# **HEARING REPORT – VOLUME ONE** NOTICE OF REQUIREMENT **DESIGNATION 6302 NORTH ISLAND MAIN** TRUNK RAILWAY LINE

## **KIWIRAIL**

# A LIMITED NOTIFIED NOTICE OF REQUIREMENT TO THE AUCKLAND COUNCIL UNITARY PLAN BY KIWIRAIL

## **18R Gordon Road**

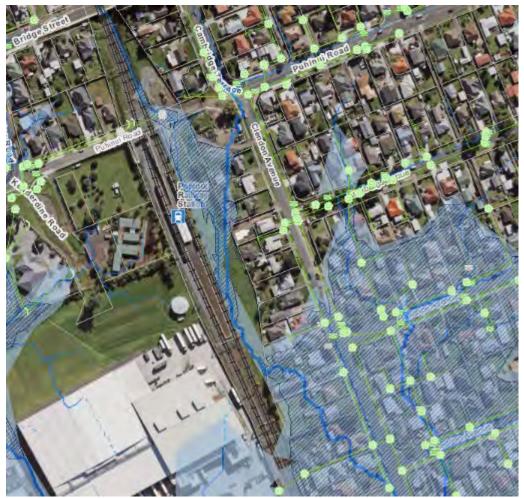
- Site is located in the Papatoetoe Tamaki River catchment and more updated modelling is available from the Healthy Waters Catchment Planning Team.
- Site is located within flood prone and floodplain areas as a result of NIMT embankments and pipe capacity beneath the railway.
- It is noted that this is proposed to be a temporary land take for construction access works and ultimately is considered to have little impact on flood levels and extent of flooding.
- When using this site, it is recommended that CCTV condition surveys be undertaken of the
  public stormwater infrastructure before and after site use to ensure that damage to the
  public network in this location can be mitigated.

## **Cavendish Drive**

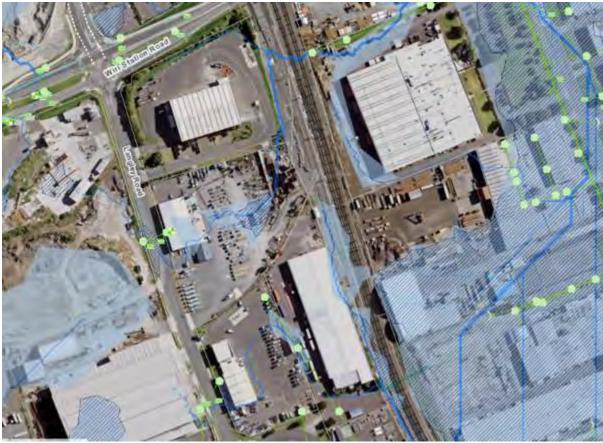
- This site is located within the Puhinui Stream catchment and has more up to date modelling results available.
- It is noted in the Jacobs report only references the temporary construction access, although the plan provided in the appendix indicates that there will also be works/land take associated with 212 Cavendish Drive.
- The northern end of 212 Cavendish Drive is within floodplain and flood prone areas which we agree will not be affected by the temporary construction access; however, if there are any permanent works within the rail corridor or 212 Cavendish Drive the potential effects on the floodplain will need to be assess and mitigation provided.
